**ST. TAMMANY PARISH**

**Addendum No.:** 1

**Bid#:** 304-00-17-44-2

**Project Name:** Woodridge Blvd Drainage and Canary Pine Ct Drainage

WOODRIDGE BOULEVARD AND  
CANARY PINE COURT  
CONSTRUCTION NOTES

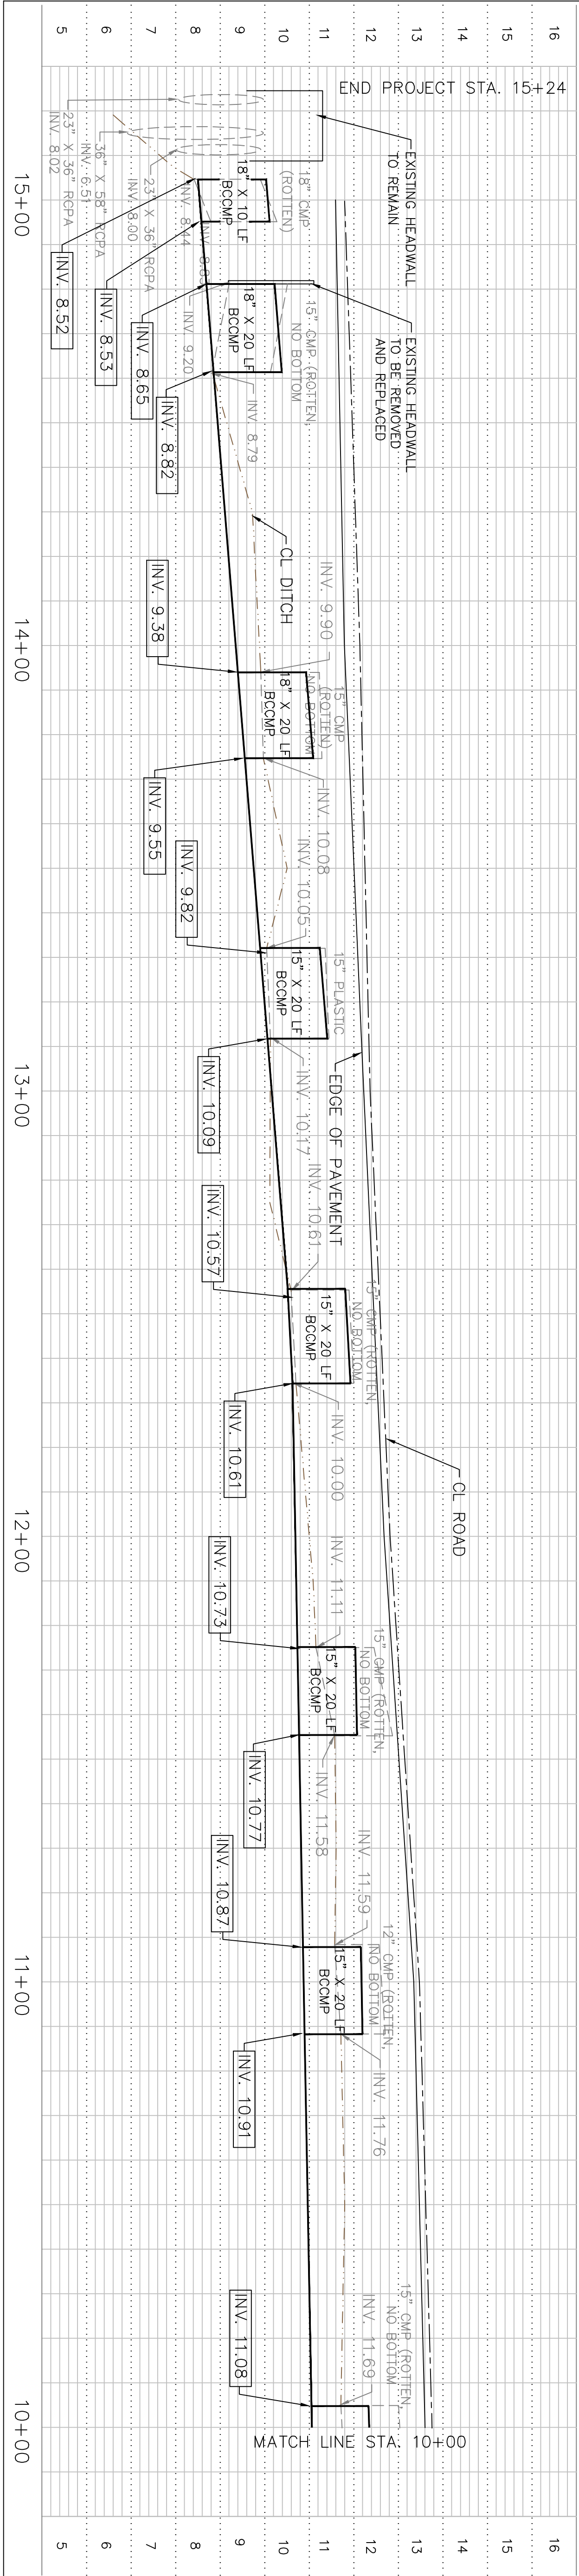
Rev. No	Date	Description
1	6/26/17	ADDED NOTE

**WOODRIDGE BLVD.**  
(WEST SIDE)

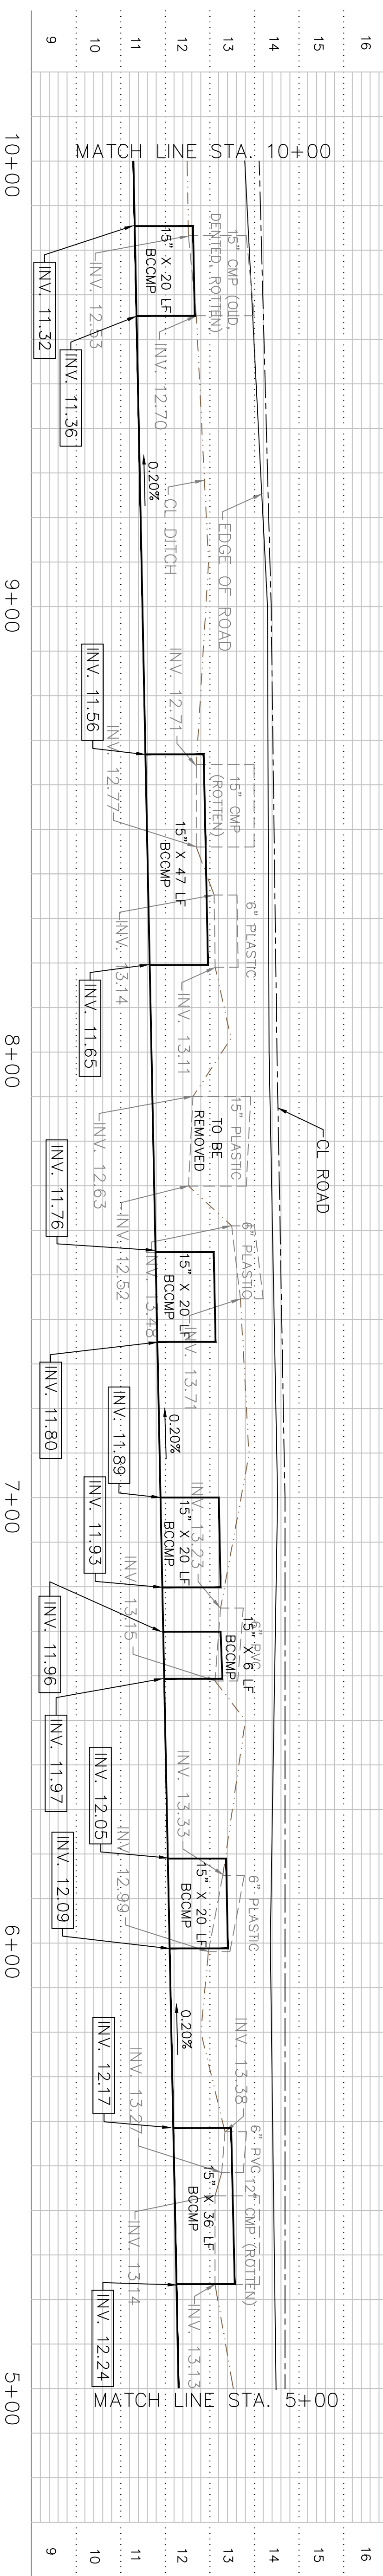
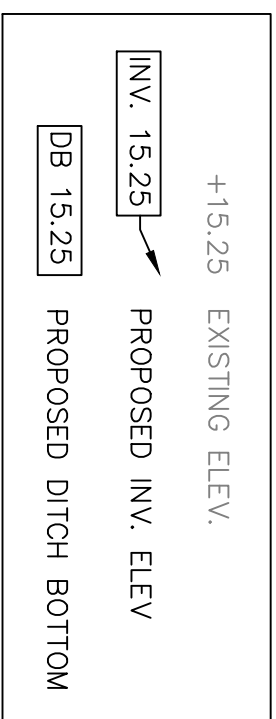
Rev. No	Date	Description
1	6/26/17	ADD DWY CULVERT; UPDATE PIPE LENGTH
